ST. LAURENT DEVELOPMENT
1740, 1754 & 1760 ST. LAURENT BOULEVARD, OTTAWA
URBAN DESIGN BRIEF FOR SPC UPDATE
JUNE, 2026

Response to submission 1

Response to Formal UDRP Comments

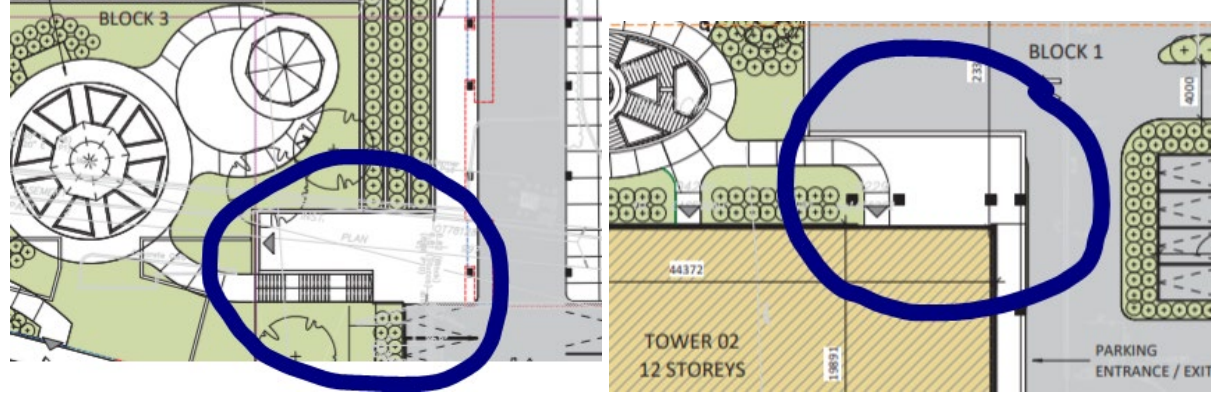
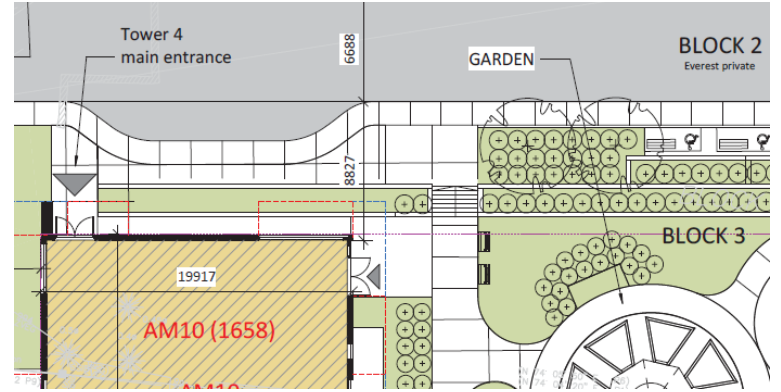
14	<p>Clarify if the Pedestrian wind level recommendation has been accounted for in the design of the entrance of Tower 4 (recessed by min 2m or re-located).</p>	<p>PMA-Architectural</p>	<p>The entrance to Tower 4 has been redesigned. Whereas the entrance was previously not recessed:</p>  <p>This has since been adjusted to be on an angled portion of the building:</p>

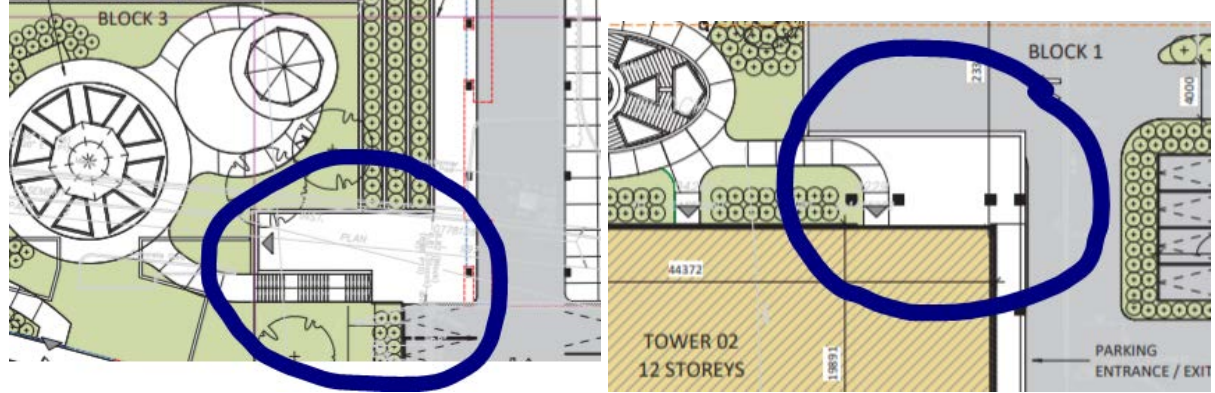
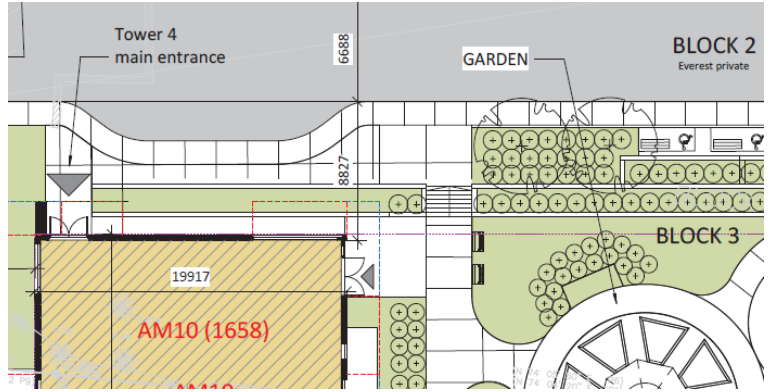
14	<p>Clarify if the Pedestrian wind level recommendation has been accounted for in the design of the entrance of Tower 4 (recessed by min 2m or re-located).</p>	<p>PMA-Architectural</p>	<p>The entrance to Tower 4 has been redesigned. Whereas the entrance was previously not recessed:</p>  <p>This has since been adjusted to be on an angled portion of the building:</p>

OCTOBER 2021

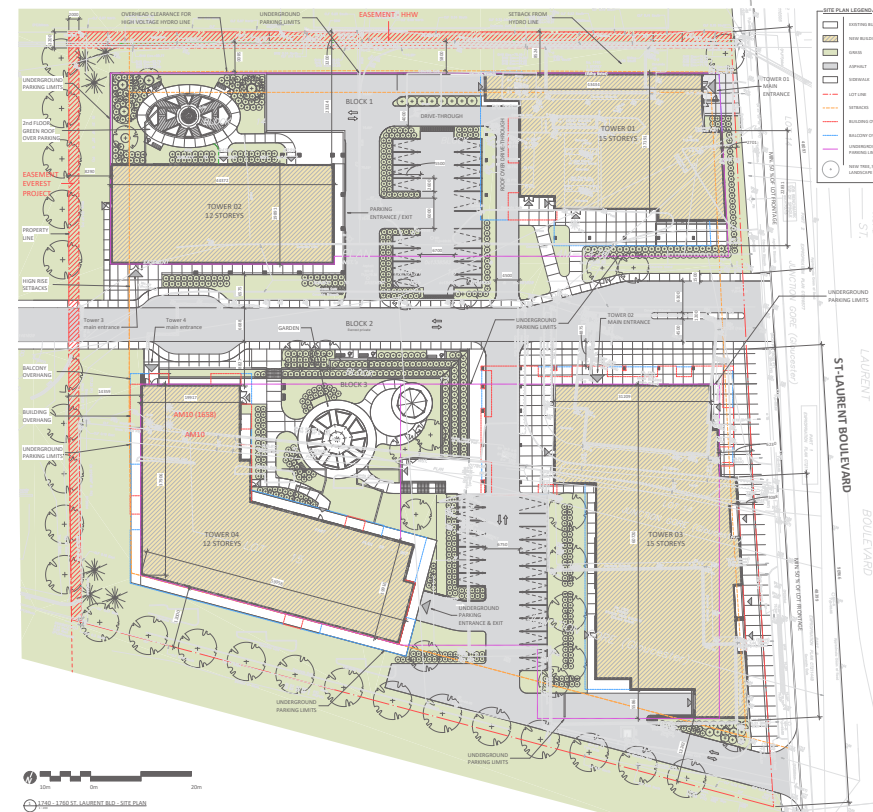
Reduce the amount of surface parking where possible to free up space for landscaping and the garden space. Reduce the surface parking adjacent to Tower 2 to the greatest extent possible to increase the size of the Garden area and improve the relationship between the Tower and Garden

Solution: Surface parking has been substantially reduced between building 3 and 4 to the benefit of the courtyard. The roof of the covert parking north east of building 2 will be landscaped and accessible to the residents.
